3-2 – 12

Proposed Change as Submitted

BALLOT COMMENTS

ICC – Kim Paarlberg**Negative Ballot**

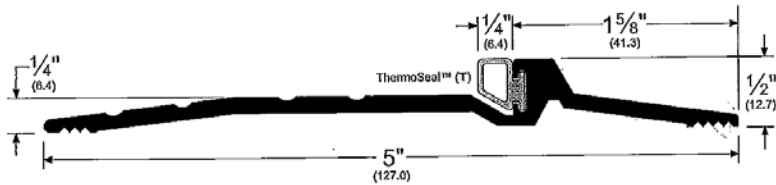
Comment/reason: I agree with BHMA-Michael Tierney and NACS- Brad Gaskins. The bump at the top of the threshold is often part of weather seals on doors and has not been shown to be a problem for accessibility. See attached example.

Figure 4 - Turning diameter (examples for various wheelchair types)

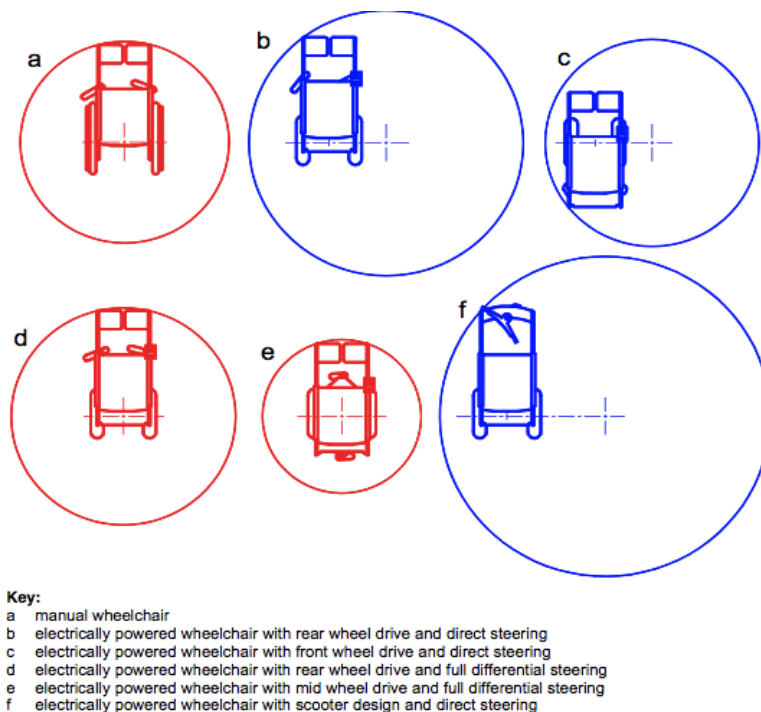
The IDeA team provided very helpful diagrams illustrating the 5 different 180 turns used by the subjects in the IDeA report. The Spot and Pivot turning techniques appear to need a width just a few inches greater than the diagonal of the user's wmd. The Shuffle turn uses whatever space is available though repeated short back and forth shuffles while turning around incrementally. The Three Point turn is a T turn with upraised arms. It was the Full U turn where both wheels move forward but the outside wheel moves faster that required the most width. The Pivot and Three Point turns use a 'corner'. The subjects were allowed to choose their preferred method for turning, but the IDeA report does not identify who used which technique, so a question exists as to who needs the extra space to successfully turn or to avoid excessive energy expenditure and who could function with less space than they used.

Further, we were informed that the best shape for a 180 turning space is a lozengen. The IDeA team recommended that the long dimension be 88 inches and the short dimension be 68 inches. Because the shape only works if a user enters the space

Option #2:

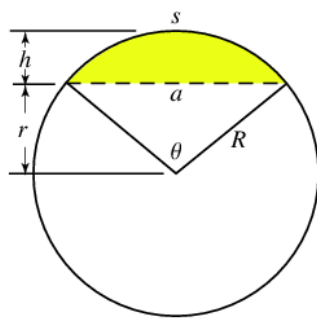
Comment: The committee disapproved this proposal because it was concerned that the proposed language was unclear and because they were not convinced that the turning circle would be usable with this change. Because we believe that the proponent was correct to want to limit the amount of space that elements can intrude into a turning space, even those with knee and toe space beneath, we propose two options for amending this proposal. Option #1 would allow on obstruction approximately 8.8" deep ($30 - (30 / 1.4142) = 8.8$) or, for a circle with a 67" diameter 9.9". Because a 90° arc will form an equilateral triangle, we divide the radius by the square root of 2, we get a segment of a 30" or 33 ½" long radius. That sum subtracted from the radius is the depth of the circle between the chord and the perimeter of the circle. Option #2 would simply not allow intrusions into the turning space.

304.3.1 Circular Space. The turning space shall be a an unobstructed circular space with a 60-inch (1525 mm) minimum diameter. ~~The turning space shall be permitted to include knee and toe clearance complying with Section 306.~~

Figure 304.3.1

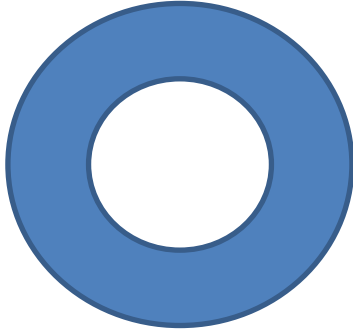
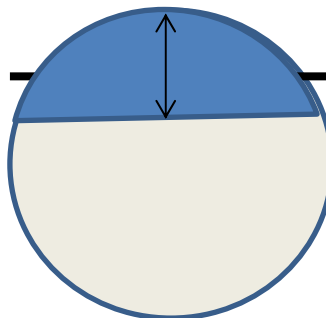
Reason: See the graphic in the ballot statement. The current circle language would allow a 'doughnut' effect. This language would allow for the current 25" maximum knee and toe clearance under a straight counter along a turning space. If the committee desires less of an overlap, the length of the cord and the depth of the sagittal could be revised accordingly.

While I agree that the permitted overlap should be addressed, I do not agree with the final modification to limit the overlap to 10" maximum. This is inconsistent with the T-turn allowance of 25 inches maximum overlap. The data from Dr. Steinfeld provided for a greater depth of 16" where knee and toe clearance were provided. If we want to make a change to the allowed depth, we should have justification and be consistent.

304.3.1 Circular Space. The turning space shall be a circular space with a 60-inch (1525 mm) minimum diameter. The turning space shall be permitted to include knee and toe clearance complying with Section 306. Where the turning space includes knee and toe clearances under an obstruction, the overlap shall comply with all of the following:

1. The depth of the overlap shall not be more than 10 inches, and
2. The depth shall not exceed the depth of the knee and toe clearances provided, and
3. The overlap shall be permitted only within the turning circle area shown shaded in Figure 304.3.1.

Proposal 3-9

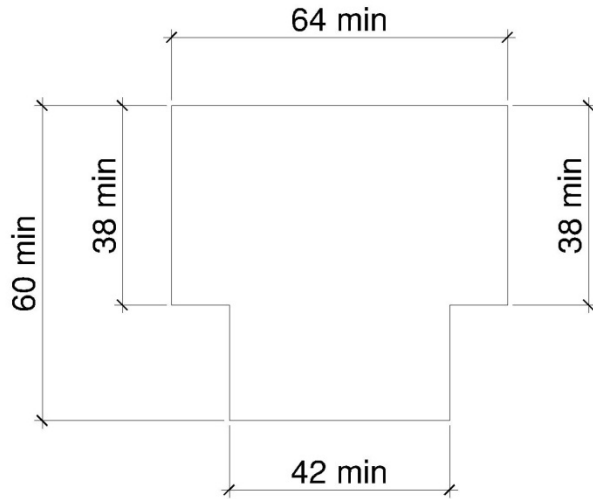
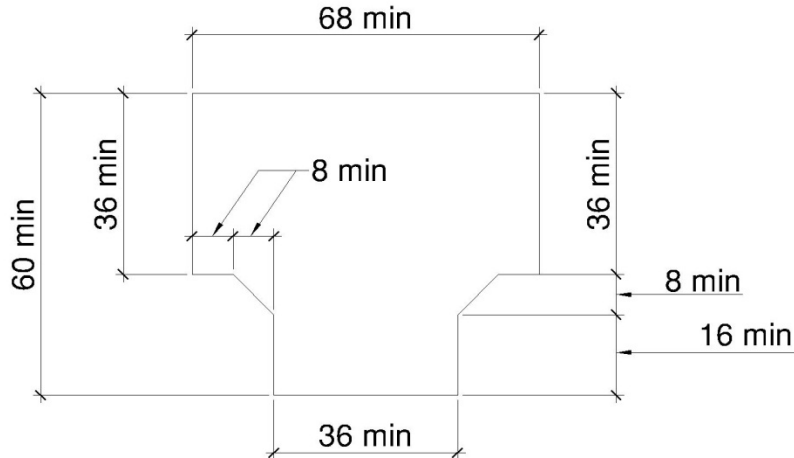
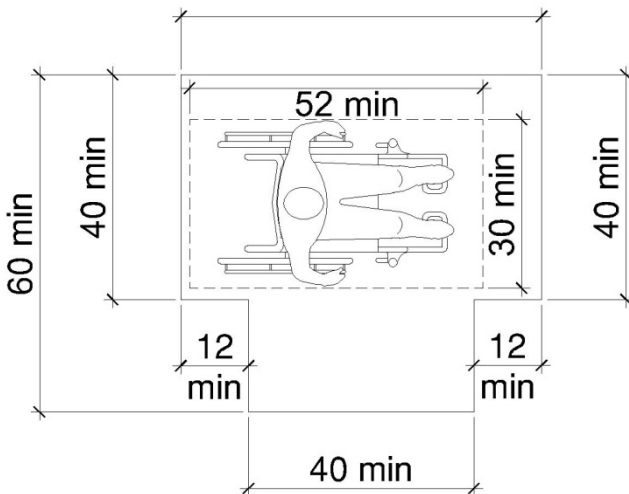
Comment: The "base" entry should be shown in the diagrams as the intended entry point is not clear from the code language (nor can I think of a clearer way of stating the requirement!)

Comment: We studied the impact of the required entry at the base on a series of apartment plans. We find that the requirement of entering at the base will add up to 12" to the depth of a typical apartment, but, if we allow entry from any arm it has little impact. Logically, there should be no difference where the entry to the T shaped area should be. I propose a modification of the original proposal to strike the language regarding entering and exiting through the base. Further, the entry and exit through the base restriction would be practically impossible, as there are many circumstances that would have multiple entry points, such as at a T-intersection of two hallways.

Committee Reason: The original action by the committee after considerable discussion during the first 2 meetings was to accept the 3 diagrams shown above as describing three acceptable alternatives to the minimum design of T-turns. The committee accepted as a modification to the approved diagrams the

308.2.1, Figure 308.2.1

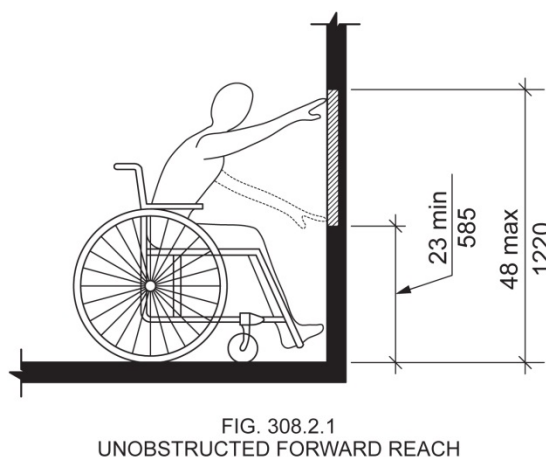
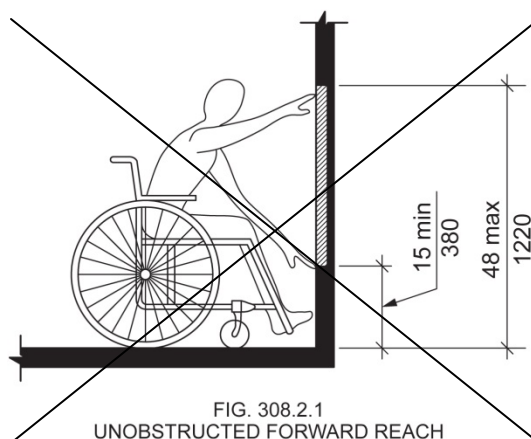
NOTE 2: This change necessitates a revision to Fig. 308.2.1 to ensure consistency. A revised figure is attached.
